**COMMISSION OF ARCHITECTURAL REVIEW
STAFF REPORT
April 24, 2018, Meeting**

8. **COA-033493-2018** (J. Jordan & D. Cooley) **2105 East Marshall Street
St. John's Church Old and Historic District**

Project Description: **Install a chain between existing concrete posts**

Metal Brackets and Screws on Concrete Posts at 2105 E. Marshall (April 2018)

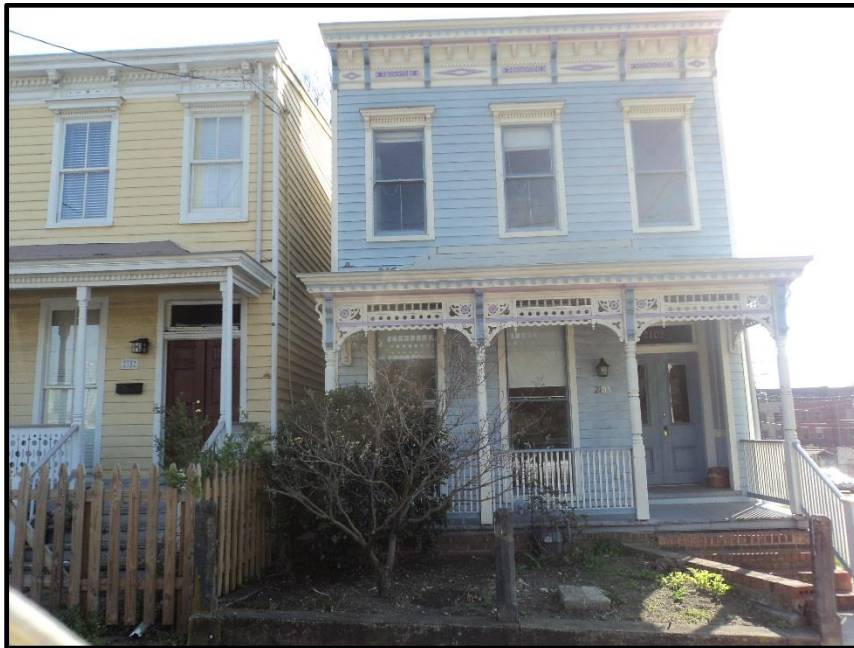
Staff recommends denial of the project. The *Richmond Old and Historic District Handbook and Design Review Guidelines* state that new street-front fences and gates should be compatible with the historic structure in design, materials, and location and should be based on physical or documentary evidence from the site (pg. 78, #3). The physical evidence indicates a metal picket fence was located between the concrete posts as metal brackets and screws remain.

Additionally, staff has located a photograph of the property from 1977 which shows a brick wall which was likely constructed in front of concrete posts. The photograph did show a metal fence between the concrete posts on the adjacent property. Staff has not located photographic evidence to support the applicant's proposed design.
